## HISTORIC AND DESIGN REVIEW COMMISSION

**HDRC CASE NO:** 2015-102  
**ADDRESS:** 511 ADAMS ST  
**LEGAL DESCRIPTION:** NCB 2915 BLK 4 LOT 3  
**ZONING:** RM4 H  
**CITY COUNCIL DIST.:** 1  
**DISTRICT:** King William Historic District  
**APPLICANT:** Katherine Valadez/Eden Lawn & Landscape, LLC  
**OWNER:** Lyle Wilson  
**TYPE OF WORK:** Front yard landscaping  
**REQUEST:**

**SHEET DESCRIPTION:**  
Landscaping Plan  
Front Yard

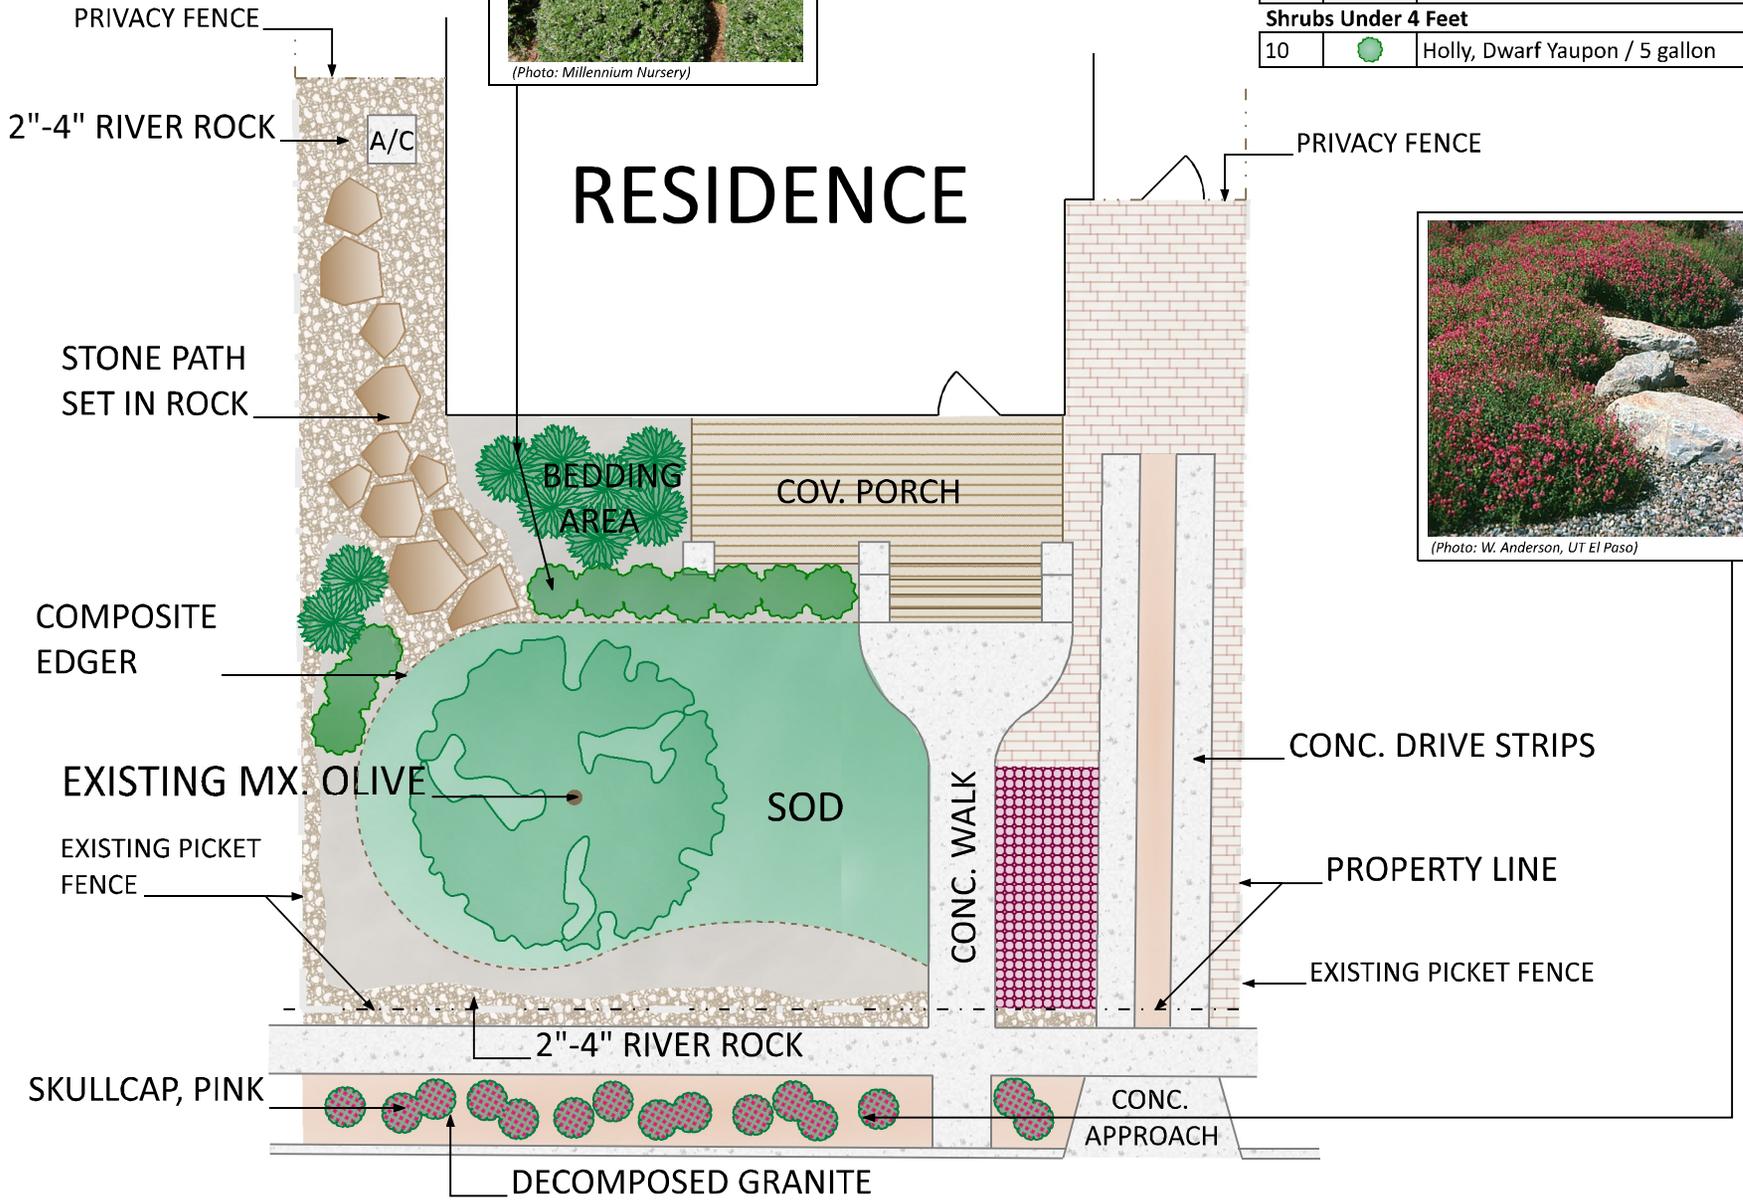
- b. The applicant has proposed to maintain a approximately fifty percent of the front yard turf while the percent that is to be removed will be replaced with 2” to 4” river rock and decomposed granite that is to have a bedding area and Shrubbery incorporated into the design. This is consistent with the Guidelines for Site Elements 3.A.ii and 3.B.iii.

- c. The applicant has proposed to move the existing turf at the sidewalk strip and to replace it with decomposed granite. The Guidelines for Site Elements state that traditional lawns in planting strips should be maintained and that if they are replaced with gravel beds that low-growing plantings should be incorporated into the design. The applicant has proposed to incorporate pink skullcap plantings into the sidewalk strip. This is appropriate with the Guidelines for Site Elements 3.B.ii.

- d. Currently, there is an area of brick pavers to the west of the existing concrete walk and front porch. The applicant has proposed to repair the existing brick pavers and replace expand the paved brick area to include the area south and west of the concrete drive strips. This is consistent with the Guidelines for Site Elements 5.A.i regarding maintenance.

- e. The applicant has proposed to expand an existing area of purple heart slightly to the north and south of its current location. This is consistent with the Guidelines for Site Elements 3.A.iii. regarding the planting of native xeric plant materials.

- i. That the applicant install plant materials to obscure the view of the existing HVAC unit on the east side of the house.
- ii. That the applicant install low growing plant materials in the area of decomposed granite between the proposed area of sod and the northern river rock border.

Staff recommends approval of item #1 based on finding b with the following stipulation:

Staff recommends approval of items #2 through #4 based on findings c through e.
